**CITY OF BATON ROUGE  
PARISH OF EAST BATON ROUGE**

**ADDENDUM NO. 2**

**SUBJECT: LOBDELL AVE/GOODWOOD BLVD AND LOBDELL AVE/SEVEN OAKS AVE  
INTERSECTION PEDESTRIAN IMPROVEMENTS PROJECT  
CITY-PARISH PROJECT NO. 23-EN-HC-021A**

GENERAL NOTES  
3-EN-HC-0021 AND 23-EN-HC-0022  
EAST BATON ROUGE PARISH

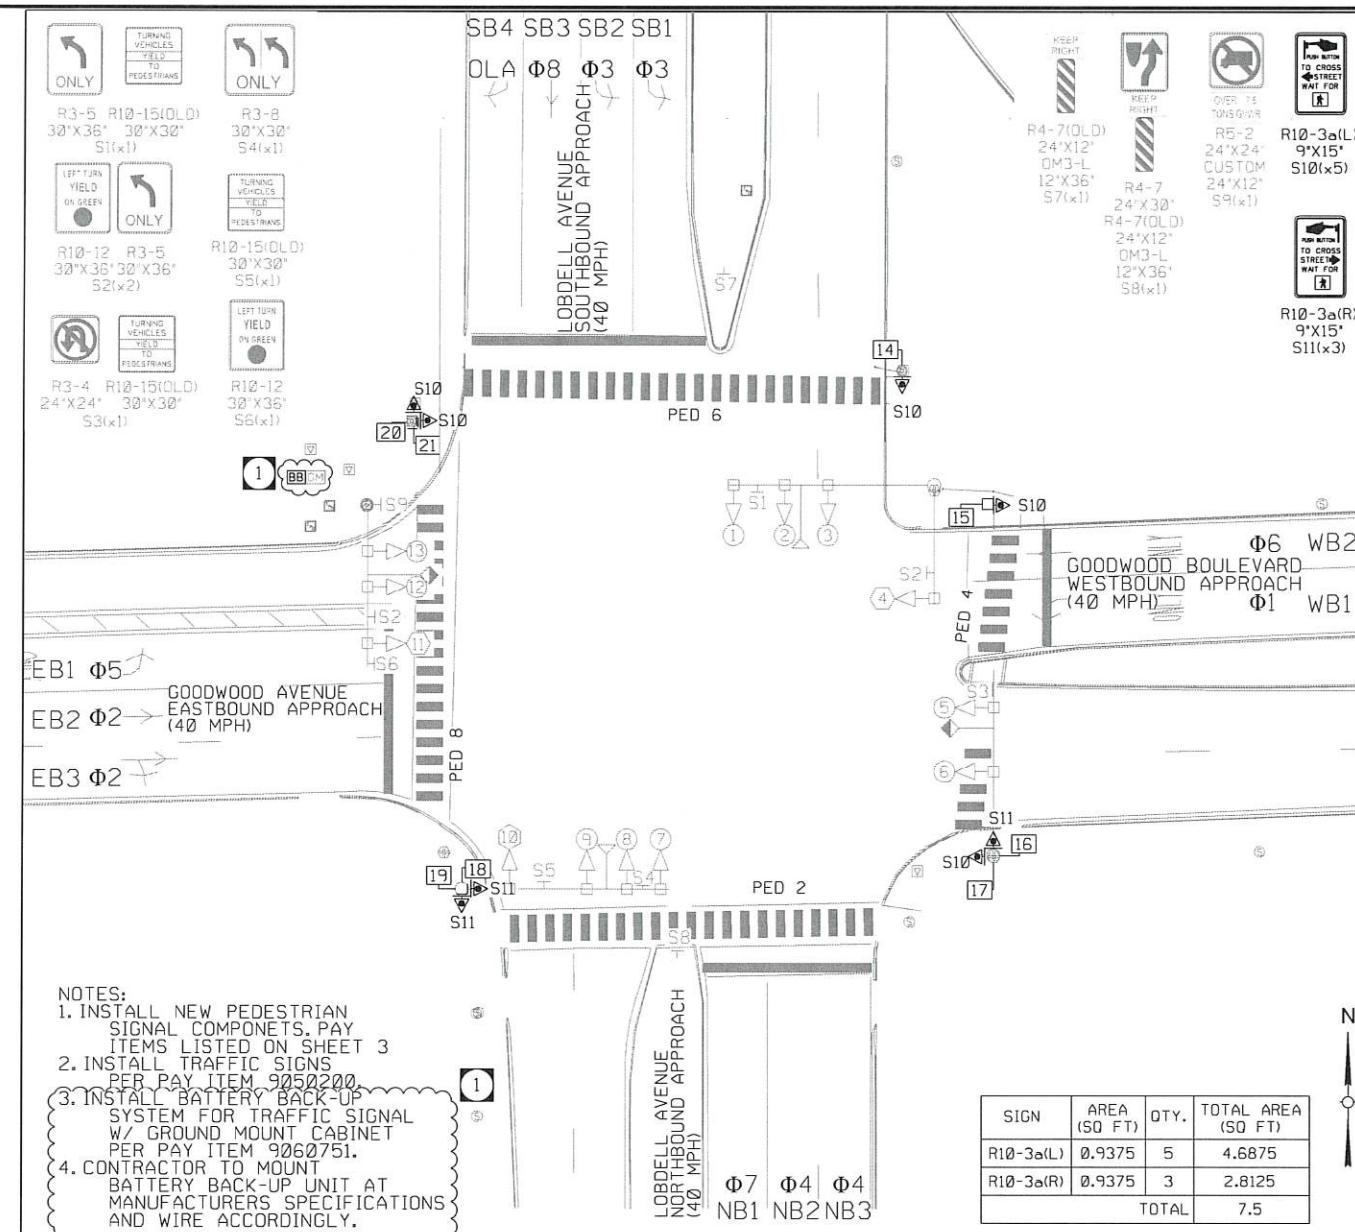
2. Note 7.1 on sheet 02 states to use Area 1 parameters for the signal pole foundations. Area 1 parameters, as shown on sheet 58, would require a 36" foundation and a 54" foundation for the 30' and 55' mast arms. The pay items are for 30" and 42" minimums. Should the pay items be adjusted?

3. Note 7.3 on sheet 02 states, "Contractor to mount battery backup units onto the proposed controller cabinets and wire accordingly." However, there is no pay item for the battery backups, and they are not reflected on the plans. Is the intent for battery backup units to be installed, and if so, where should this cost be absorbed?

- **Note 7.1 on Sheet 02 should reference Area 2 parameters. The pay items for 30" and 42" are correct for the 30' and 55' mast arm foundations per CPSP 906-04. Refer to revised Sheet 02 included in this Addendum.**

- **Pay items 9060750 and 9060751 have been added to the Contract Documents to address this. Refer to revised Sheet 02 and revised Unit Price Form included in this Addendum.**

- 7.1 SIGNAL POLE FOUNDATIONS SHALL CONFORM TO AREA 2 PARAMETERS AS CITED IN THE C-P STANDARD PLAN NO.906-04.
- 7.2 EXISTING PAVEMENT MARKINGS BETWEEN THE PROPOSED STOP BAR AND THE CROSSWALK TO BE REMOVED BY GRINDING AT NO DIRECT PAY.

- 7.3 CONTRACTOR TO MOUNT BATTERY BACKUP UNITS ONTO THE PROPOSED CONTROLLER CABINETS AND WIRE ACCORDINGLY.
- 7.4 CONTRACTOR TO COORDINATE WITH ENTERGY TO INSTALL POWER SERVICES FOR NEW TRAFFIC SIGNAL CONTROLLERS FROM GROUND MOUNTED TRANSFORMERS, AS SHOWN.

INTERSECTION, LOBDELL AVENUE AT GOODWOOD BOULEVARD

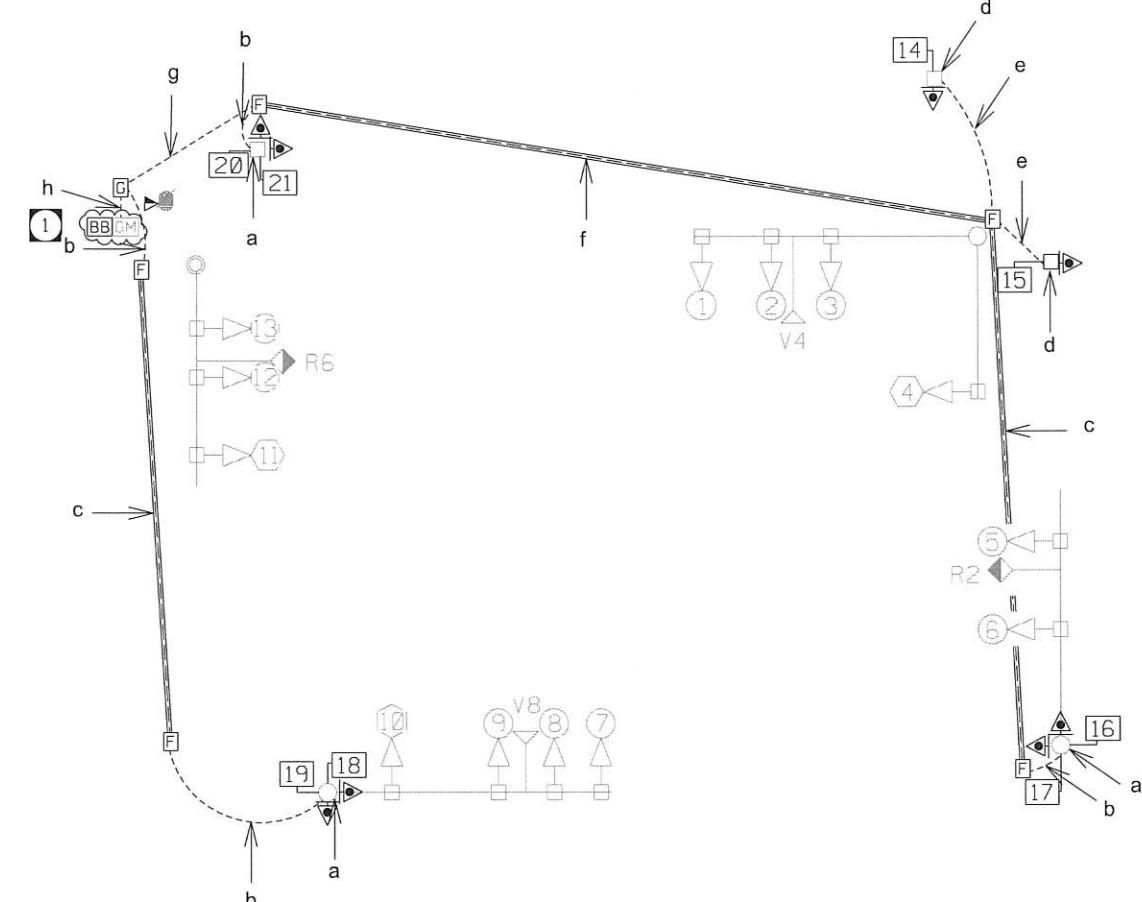
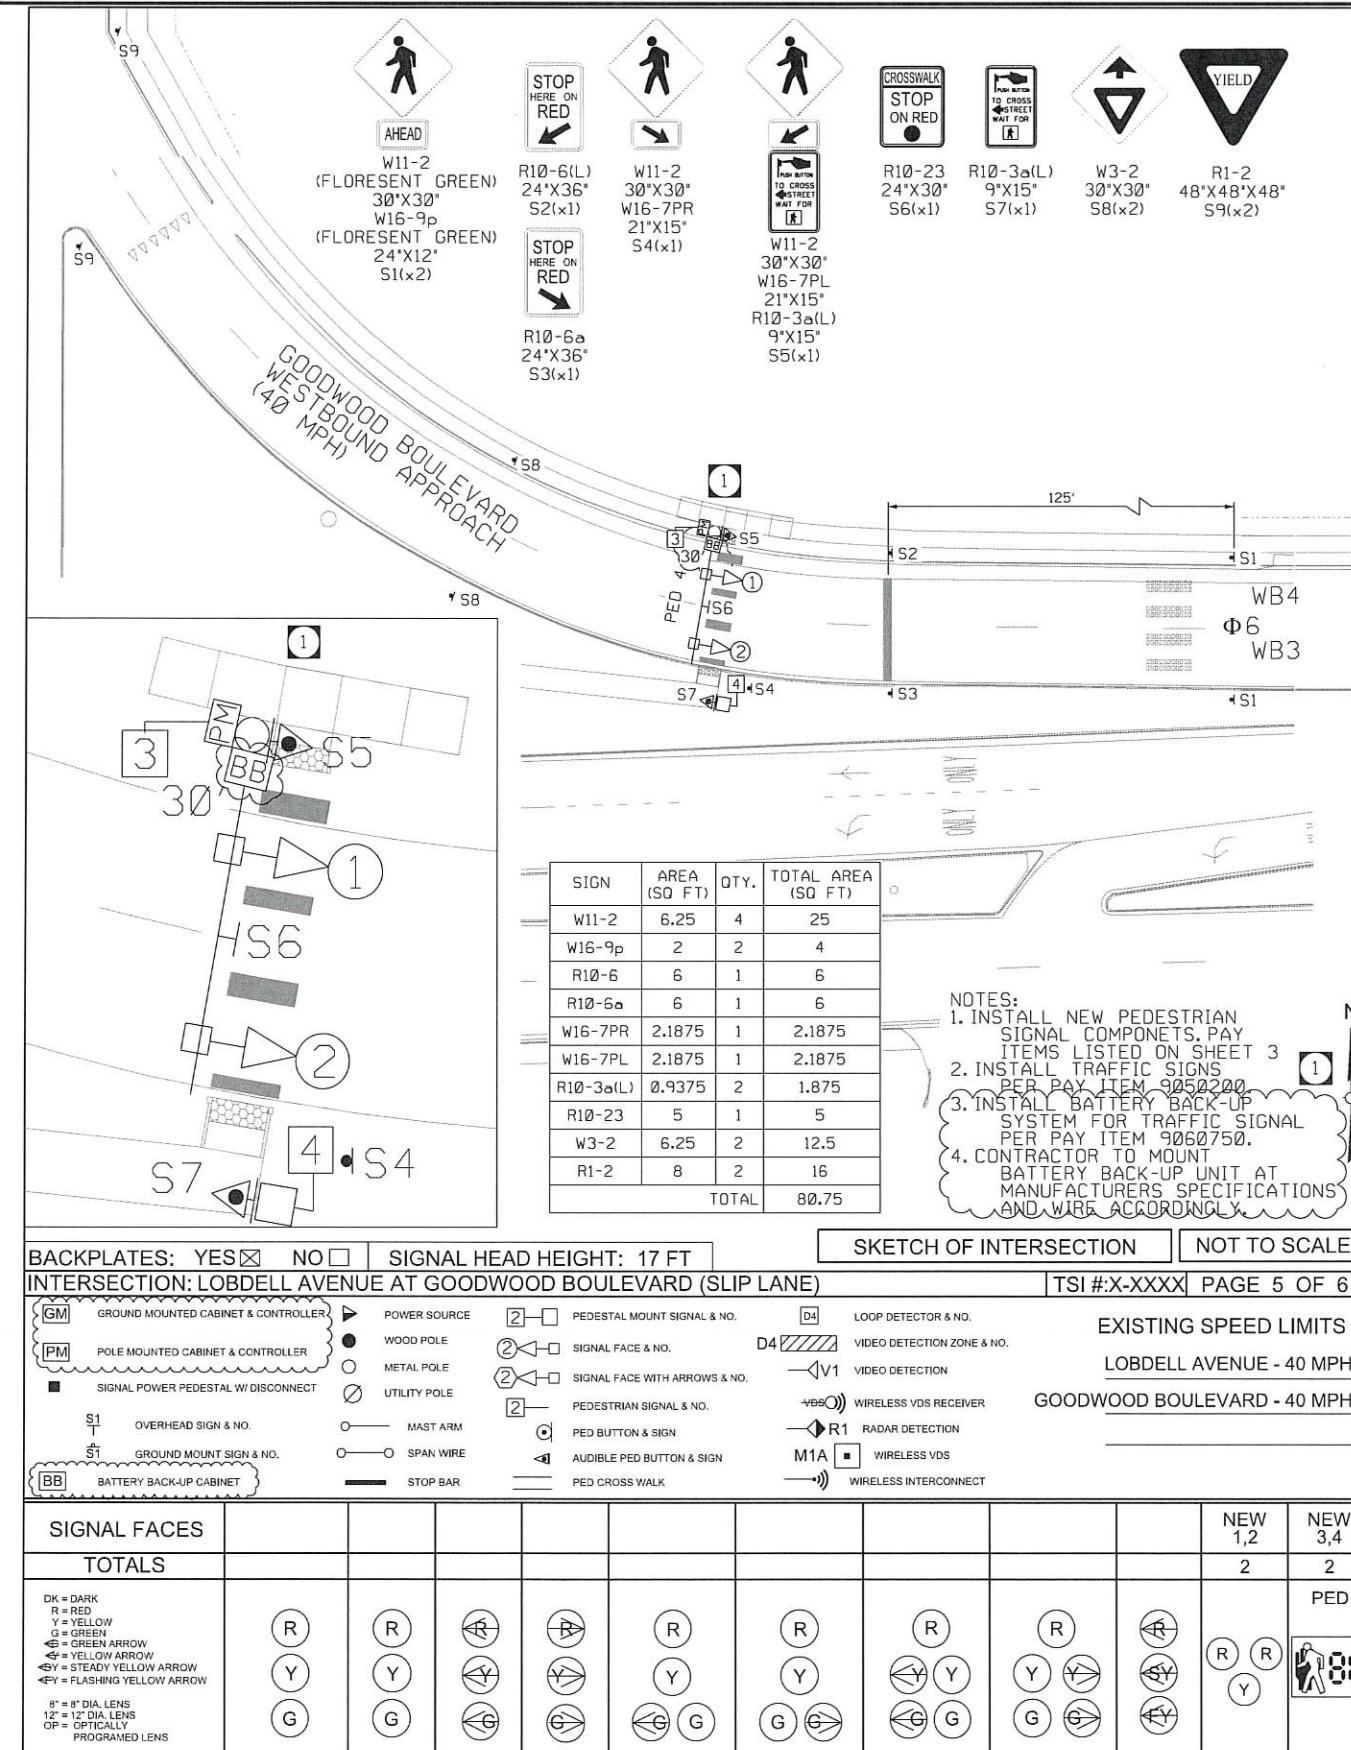
4. It seems the TSIs show 5 EA Signal Pole (Pedestal Pole) and the associated 24" foundations. However, the pay items reflect a quantity of 3 EA respectively. Is this accurate?

- **Sheet 08 (Goodwood) indicates Ped Heads Nos. 14, 20, and 21 to be mounted to existing pedestal poles; Ped Head No. 15 requires a new stand-alone pedestal pole (QTY 1)**
